## DEVELOPMENT APPLICATION ASSESSMENT REPORT

<b>Application Number:</b>	DA2025/0539
----------------------------	-------------

<b>Responsible Officer:</b>	Olivia Ramage
<b>Land to be developed (Address):</b>	Lot 52 DP 12838, 154 Plateau Road BILGOLA PLATEAU NSW 2107
<b>Proposed Development:</b>	Alterations and additions to a dwelling house including a swimming pool
<b>Zoning:</b>	C4 Environmental Living
<b>Development Permissible:</b>	Yes
<b>Existing Use Rights:</b>	No
<b>Consent Authority:</b>	Northern Beaches Council
<b>Land and Environment Court Action:</b>	No
<b>Applicant:</b>	Elaine Richardson Architect

Figure 1 - South-western elevation showing envelope encroachment in red

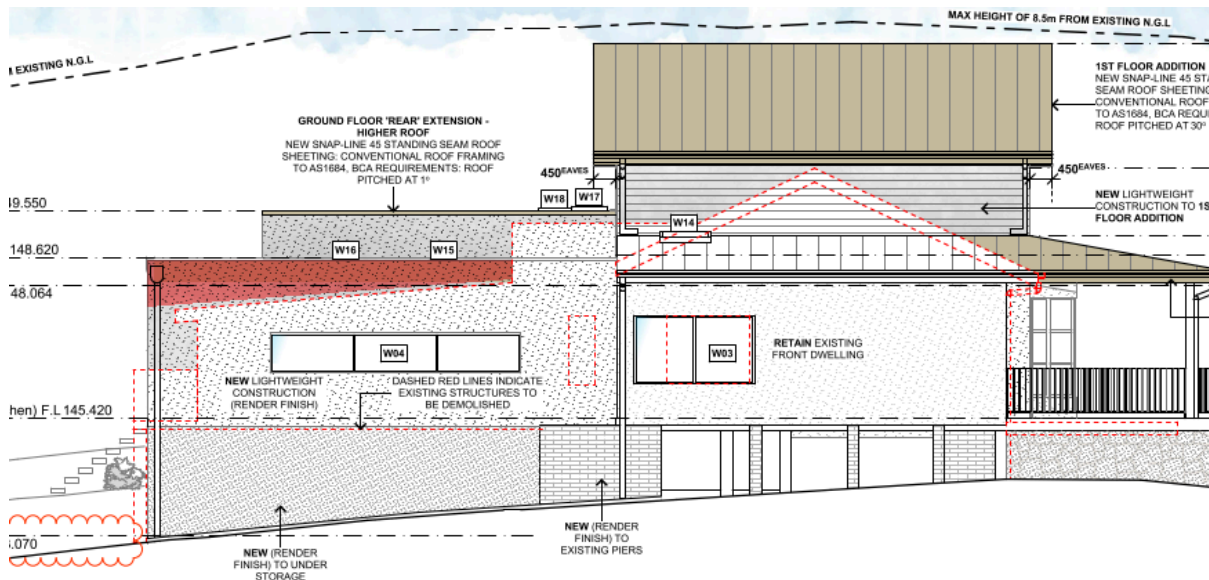
The proposed development encroaches the south-western side building envelope as shown below.
